Executive Director's Recommendation

PROJECT
Consolidated Planned Unit Development and Related Map Amendment at Square 744S and 744SS (DC Water)
O Street Pumping Station
Bound by N Pl. SE, Canal St. SE, private property, and the Anacostia River

NCPC FILE NUMBER
ZC 15-14

APPLICANT'S REQUEST
Approval of report to the Zoning Commission of the District of Columbia

ROOF PLAN

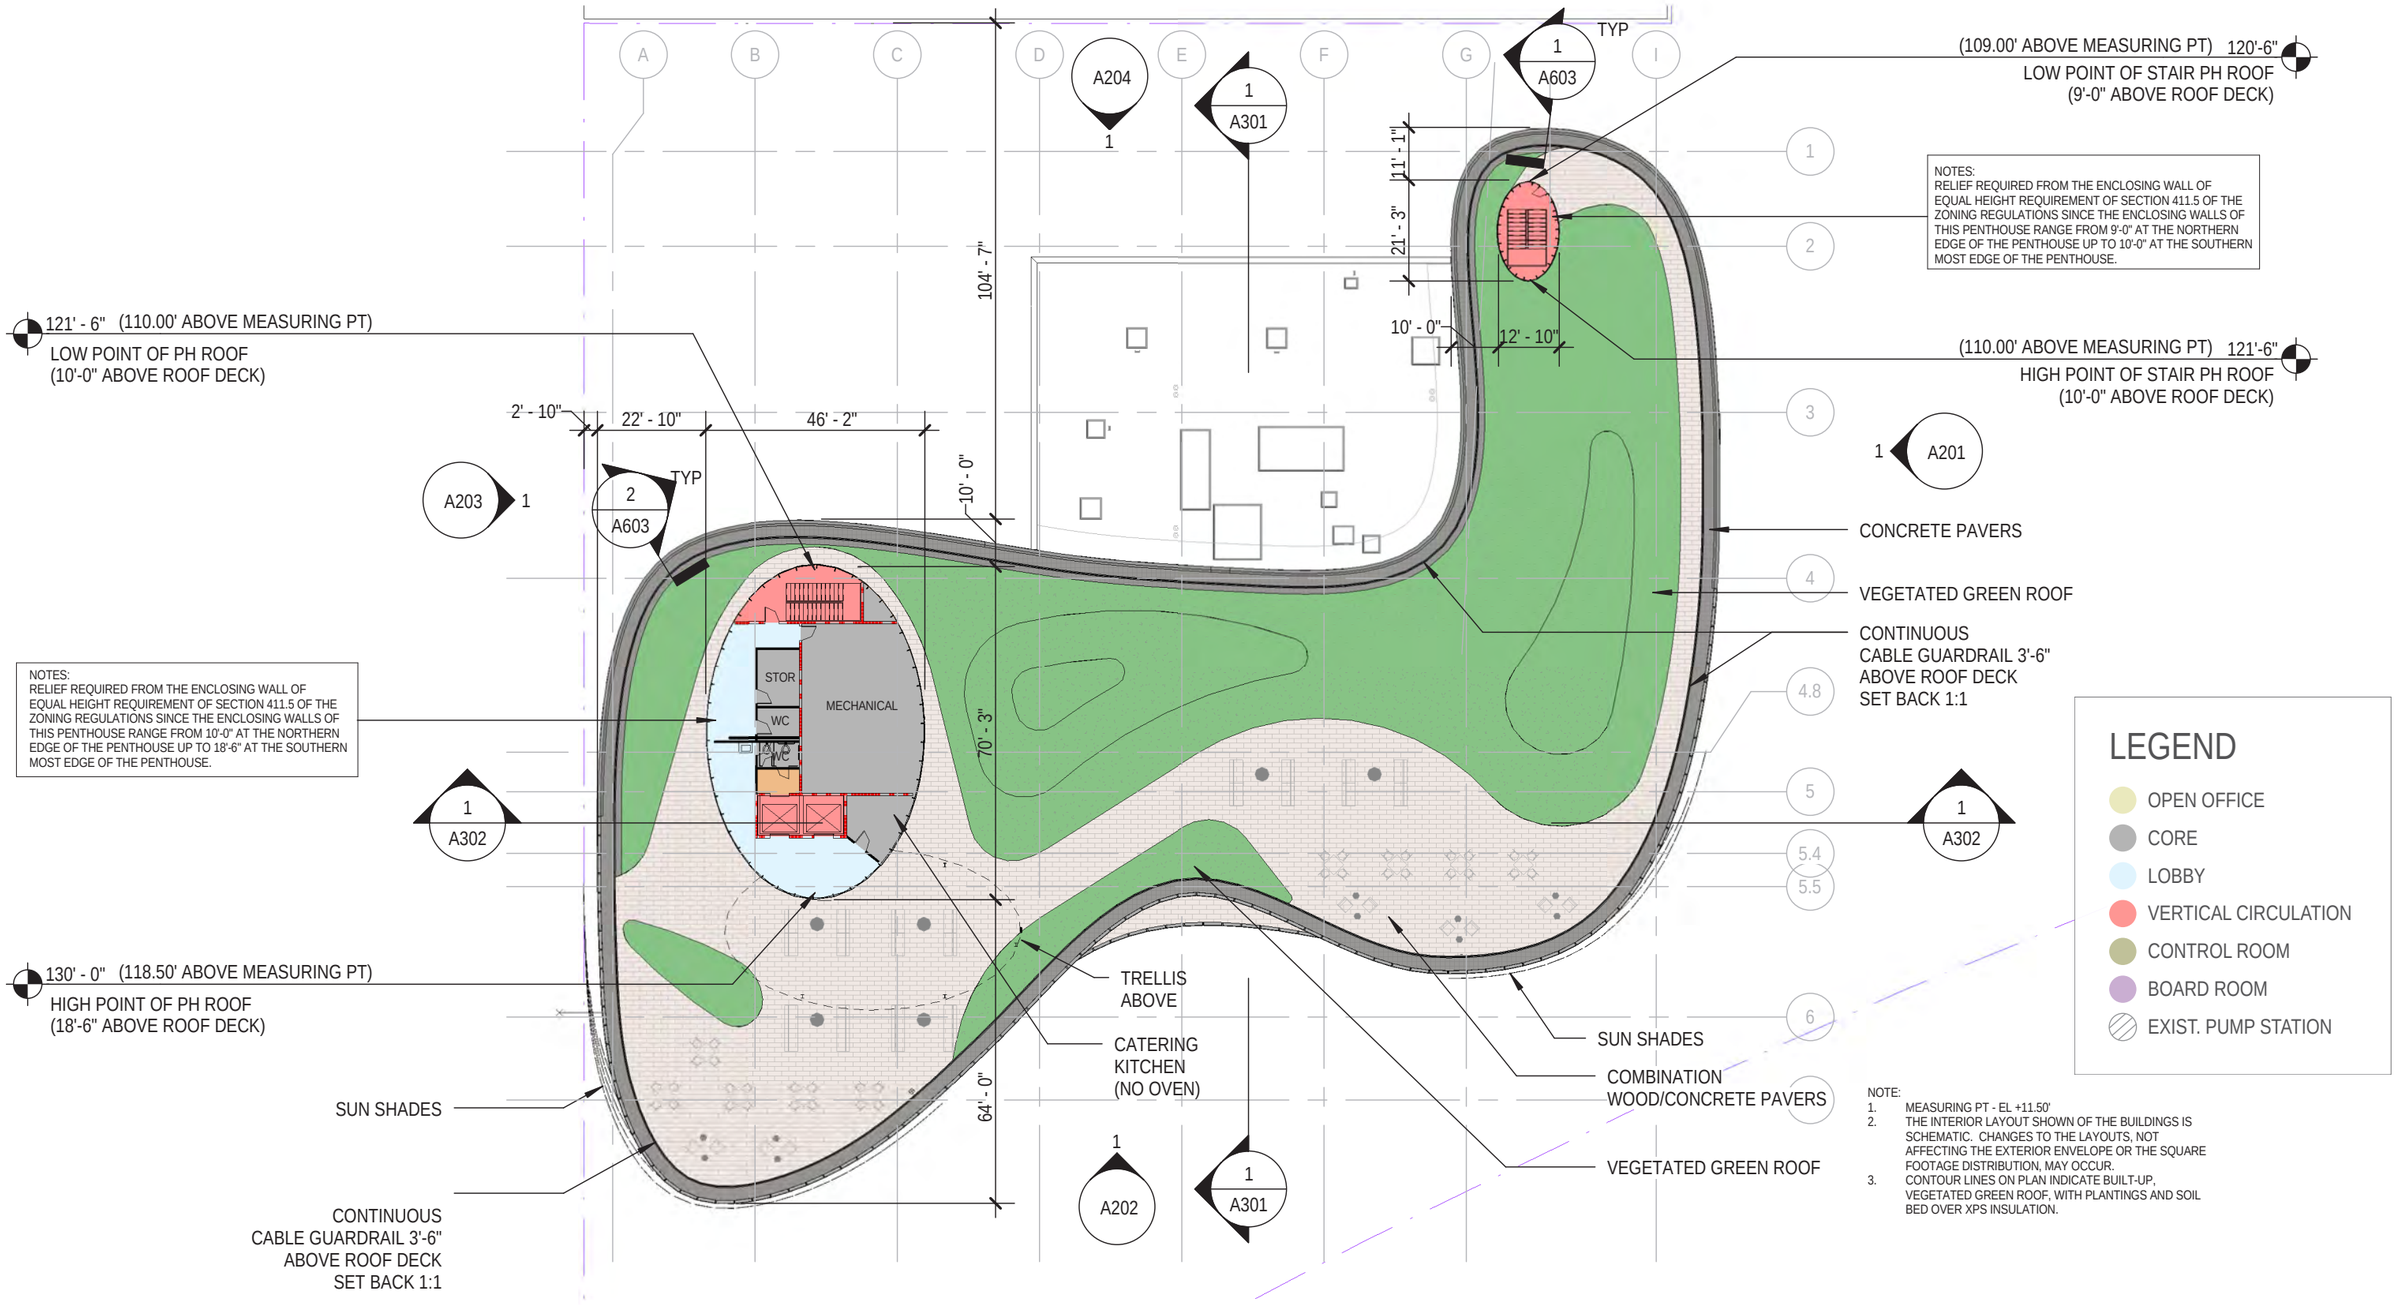
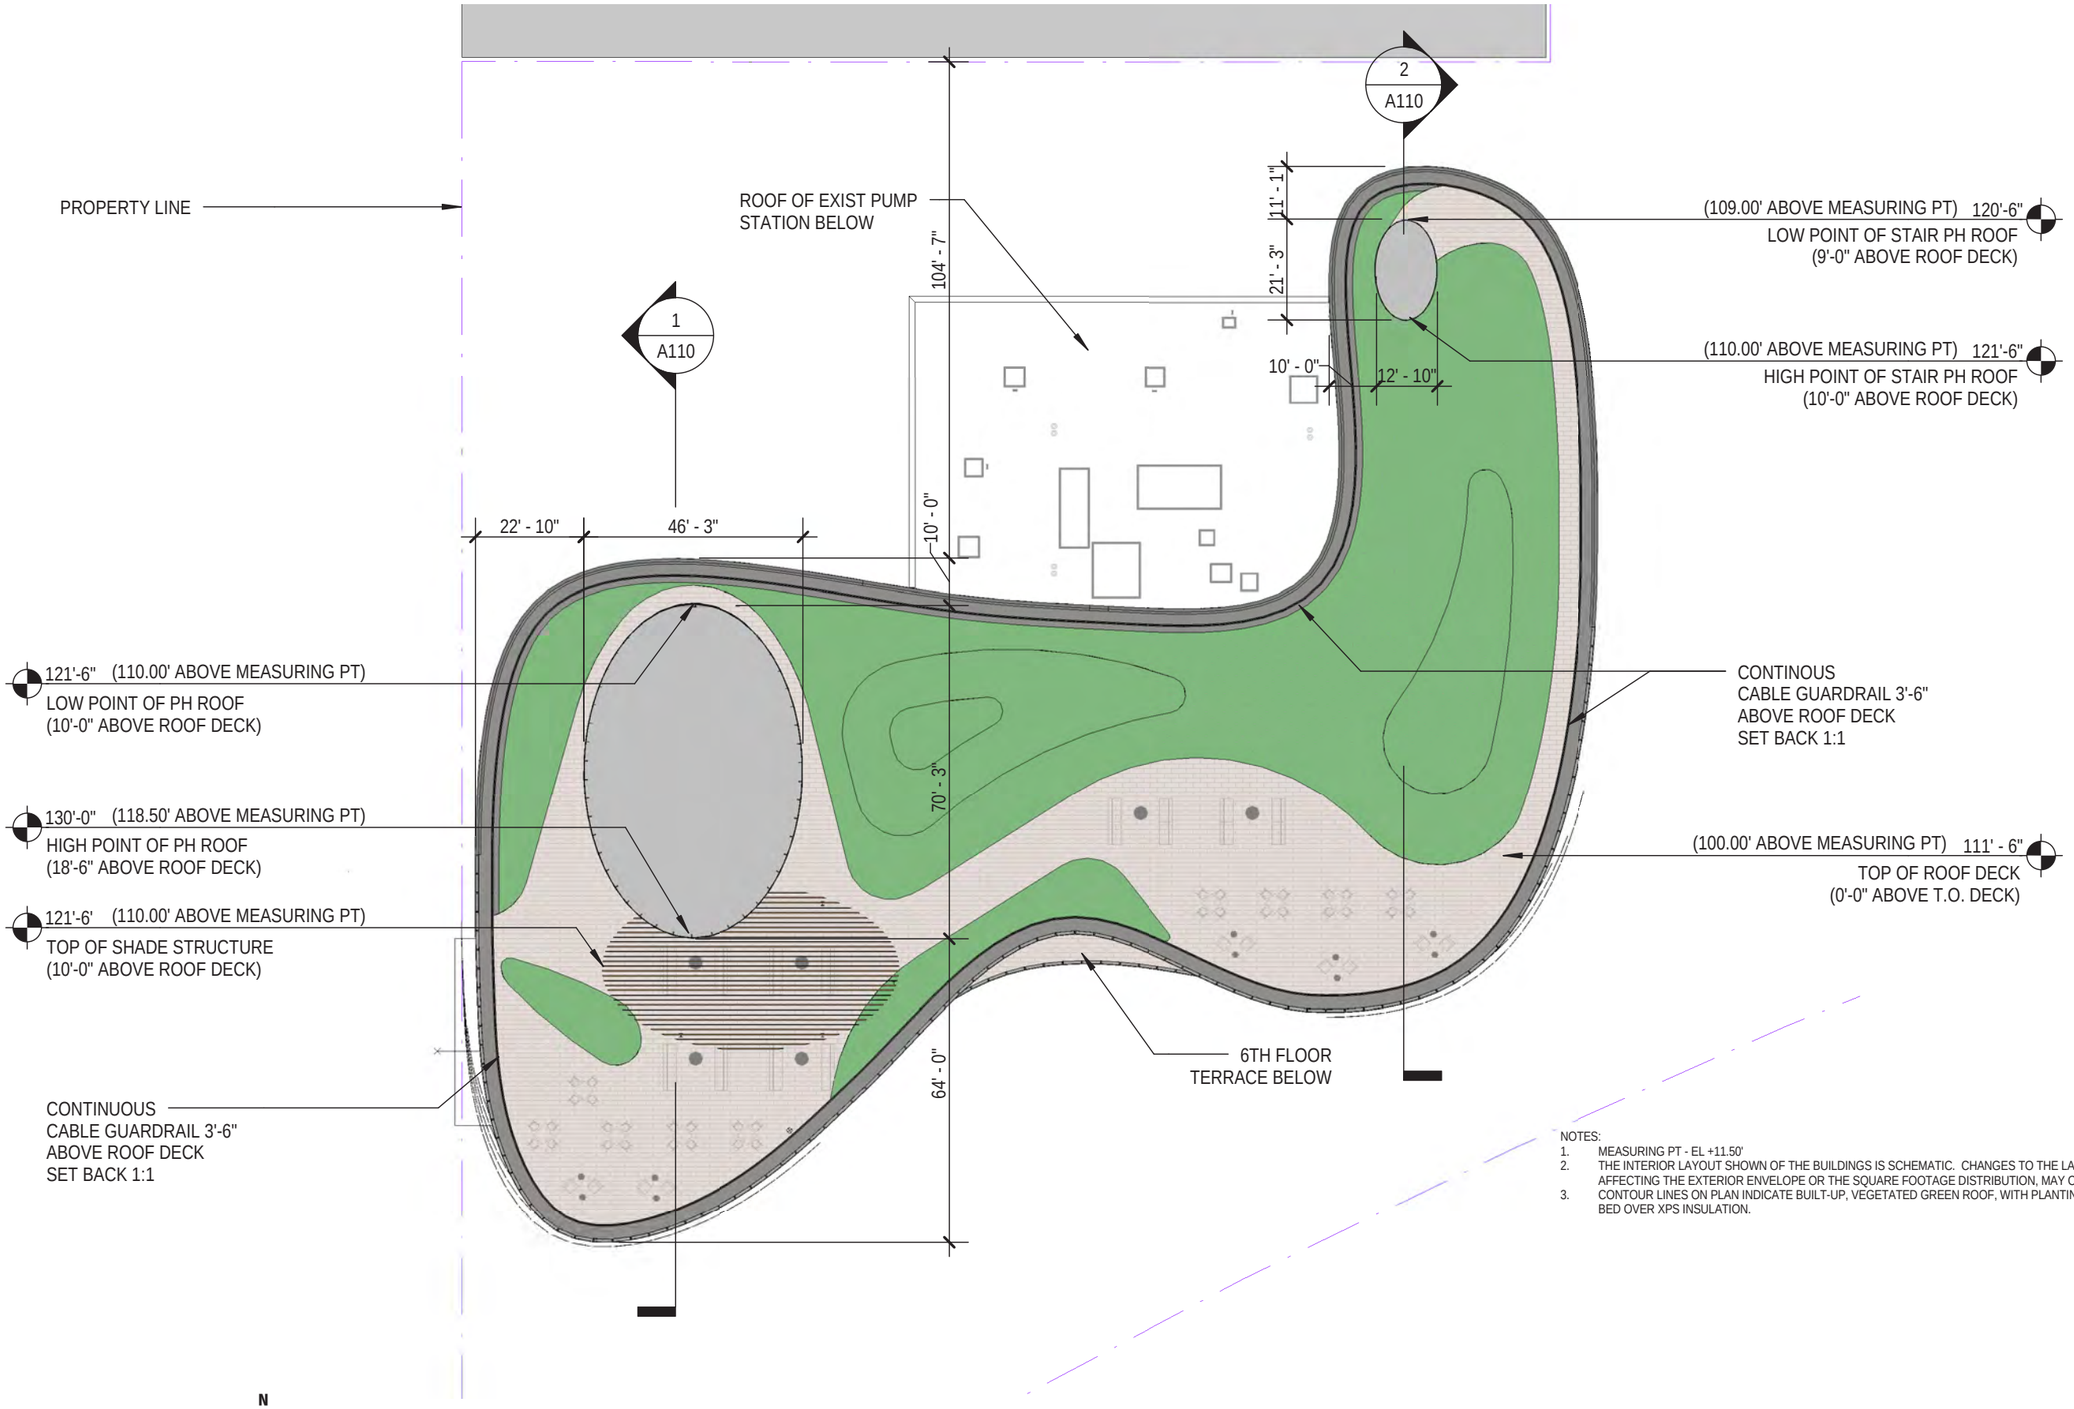
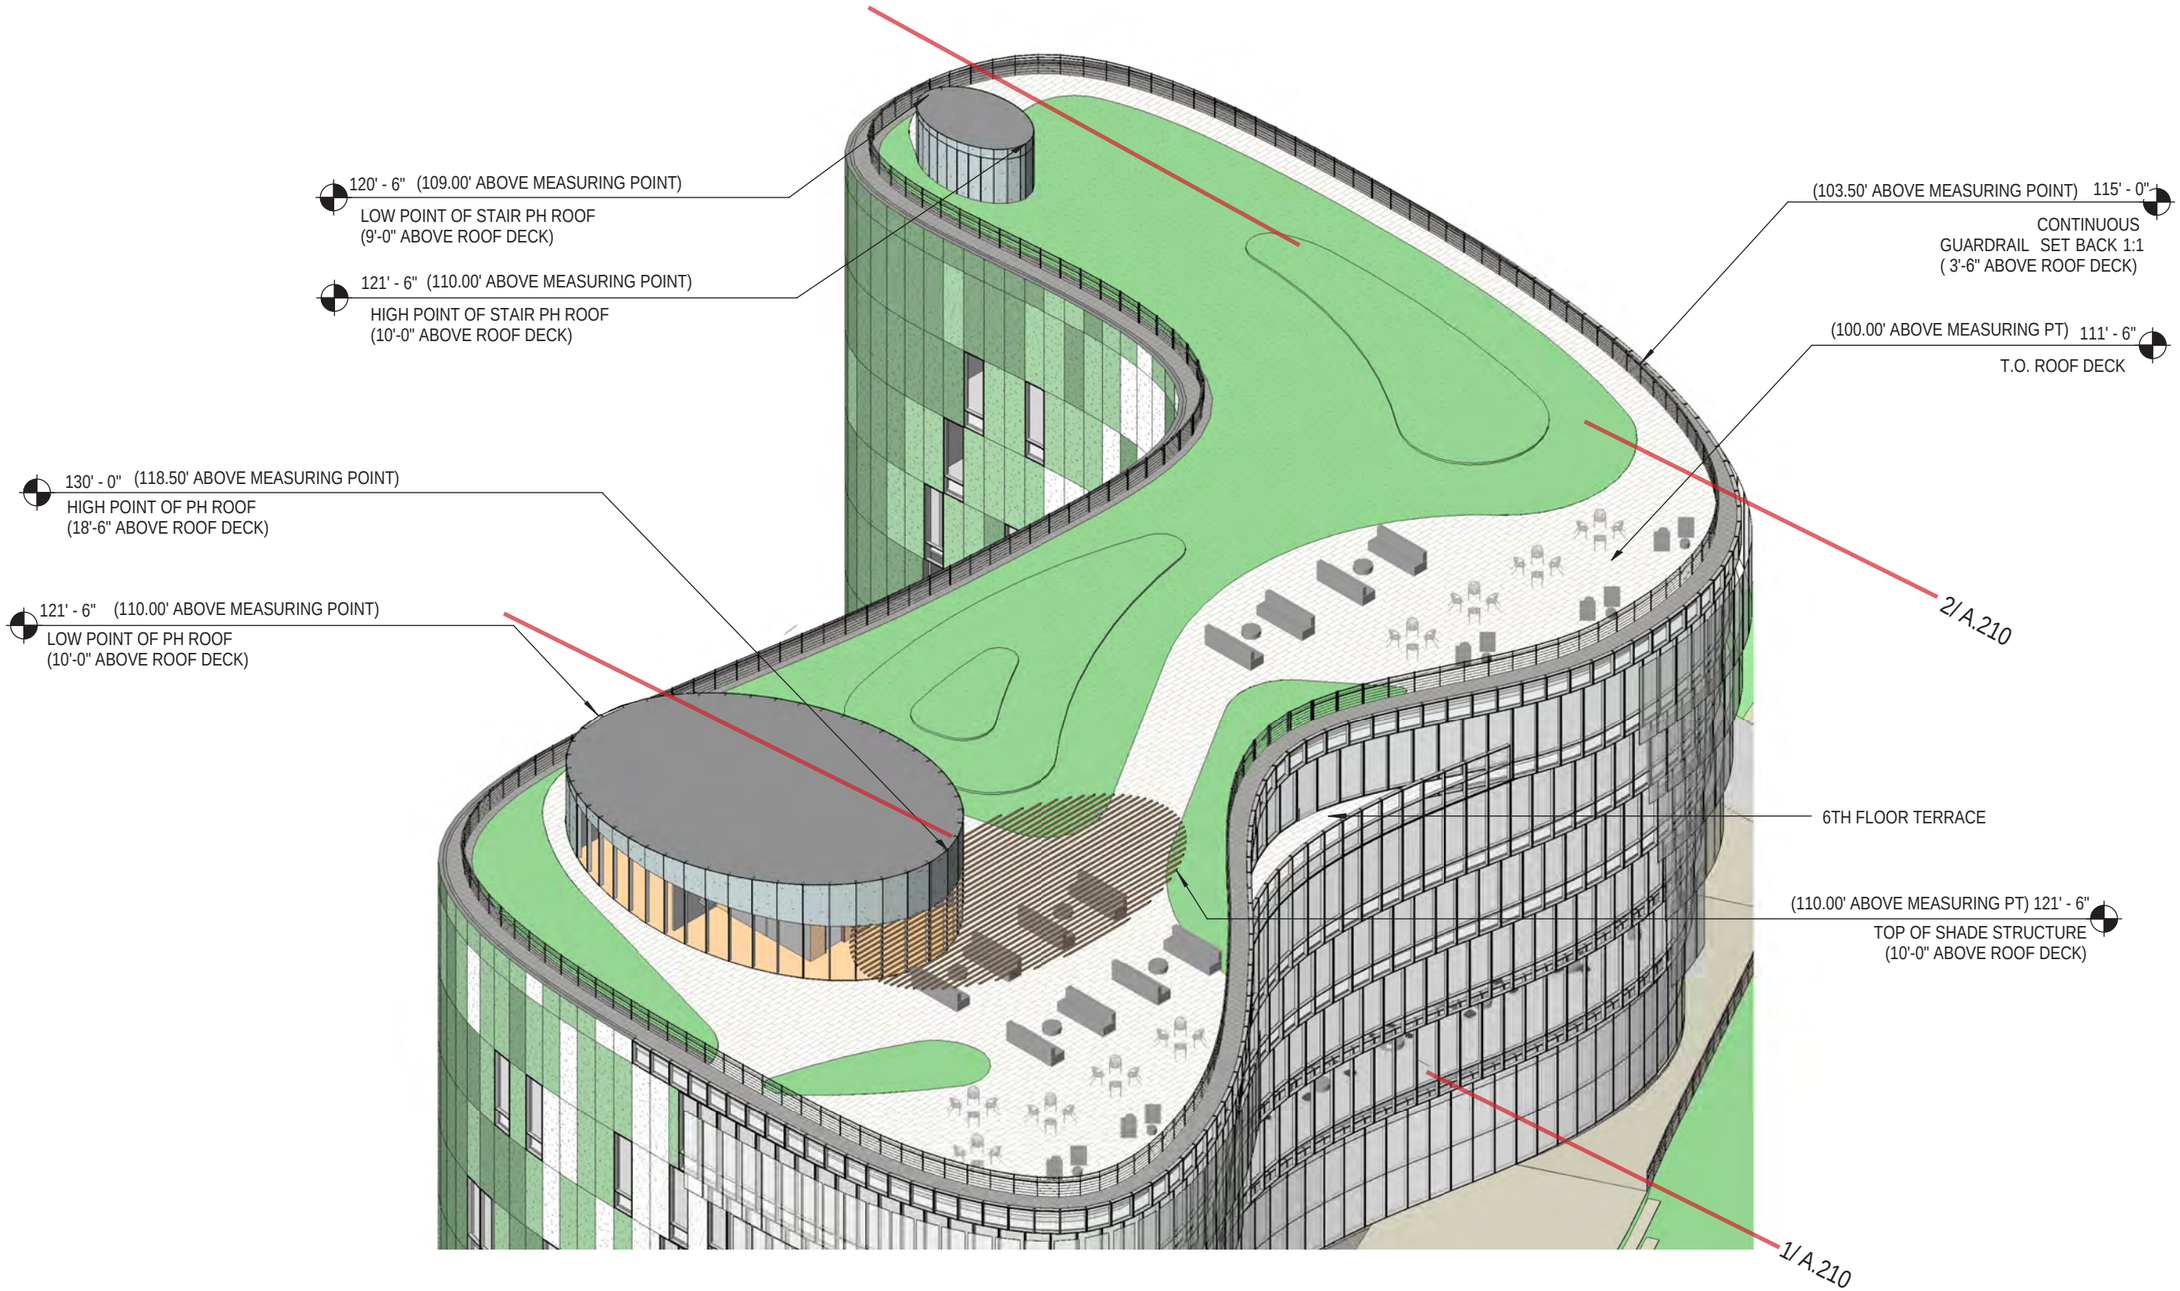
- The Consolidated PUD's proposed height of 100 feet is at the allowable height under the Height of Buildings Act (Height Act) feet based on the 80-foot right-of-way width of Canal Street SE. On December 21, 2015, the applicant provided revised drawings to the Zoning Commission that eliminated a proposed parapet that exceeded the allowable height under the Height Act; the revision now includes a continuous 3'6"-high guardrail that is set back from the roof edge at a 1:1 ratio, which conforms to Height Act requirements.
